1997 - 1998 Corvette: Service Bulletin: Discoloration or Staining of Plenum (Cowl) Air Inlet Screen

Number: 83-15-11

Models: 1997-1998 Chevrolet Corvette

Figure 1

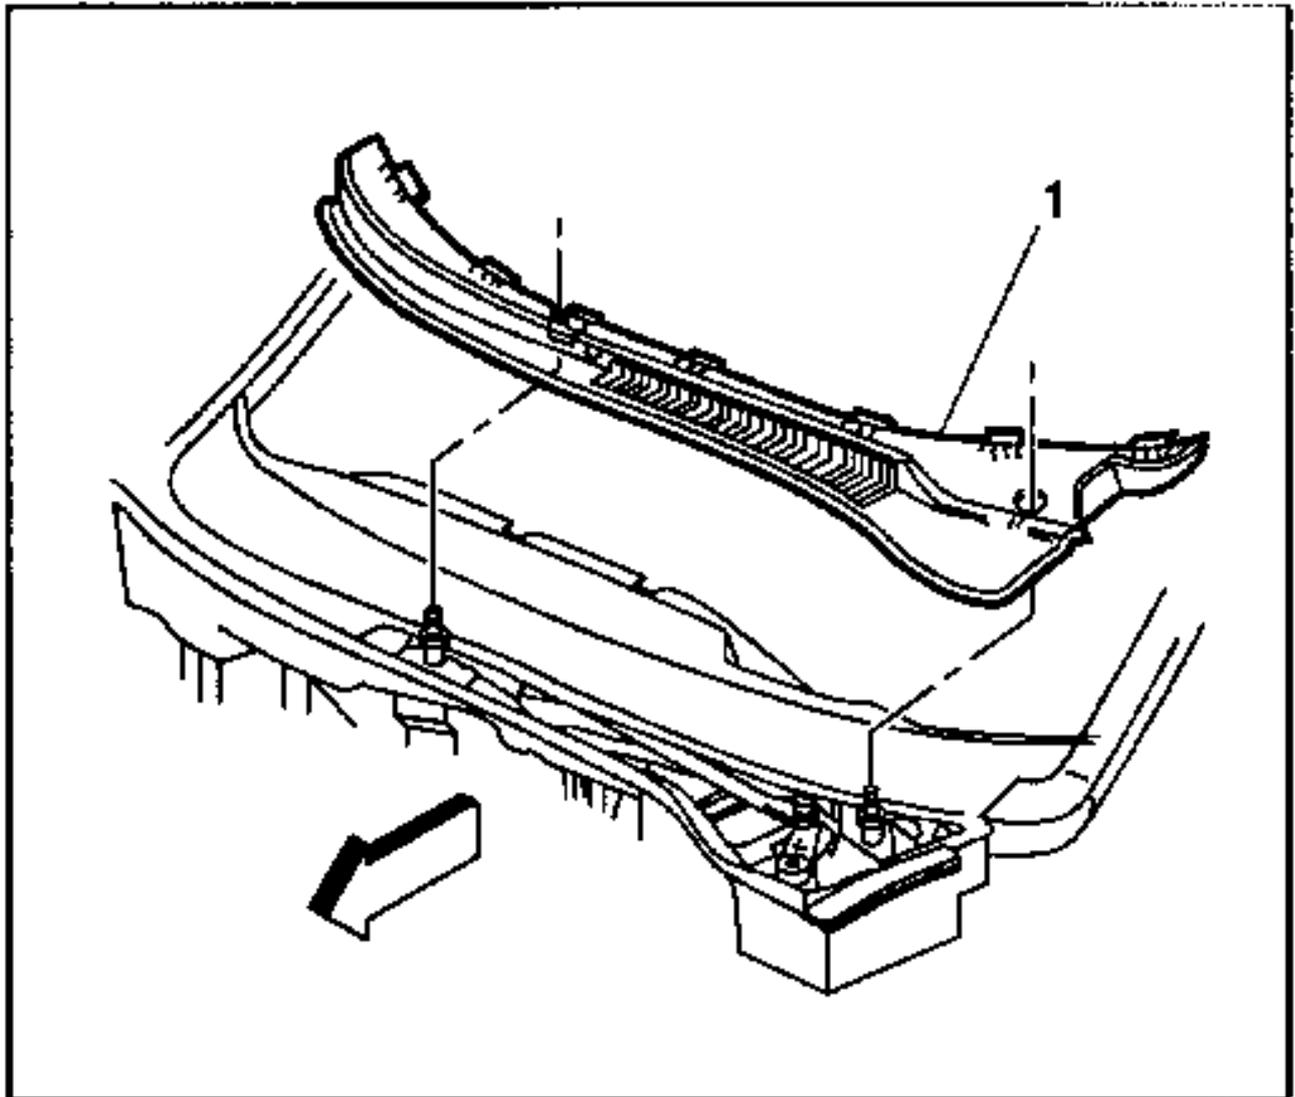
Condition: SOME CUSTOMERS MAY COMMENT THAT THERE ARE WHITISH SPOTS OR STAINS ON THE PLENUM AIR INLET SCREEN AT THE BASE OF THE WINDSHIELD. THESE SPOTS OR STAINS ARE USUALLY FOUND IN THE AREAS AROUND AND BELOW THE WINDSHIELD WIPER ARMS AND BLADES.

THIS CONDITION MAY BE CAUSED BY A CHEMICAL RESIDUE USED IN THE MANUFACTURING PROCESS OF THE WINDSHIELD WIPER WASHER NOZZLES. RESIDUE IS WASHED OUT FROM INSIDE THE NOZZLES DURING THE FIRST FEW USAGES OF THE WINDSHIELD WIPER WASHERS.

INSTALL NEW AIR INLET SCREEN (P/N 10418245), USING THE PROCEDURES IN THE APPROPRIATE SERVICE MANUAL
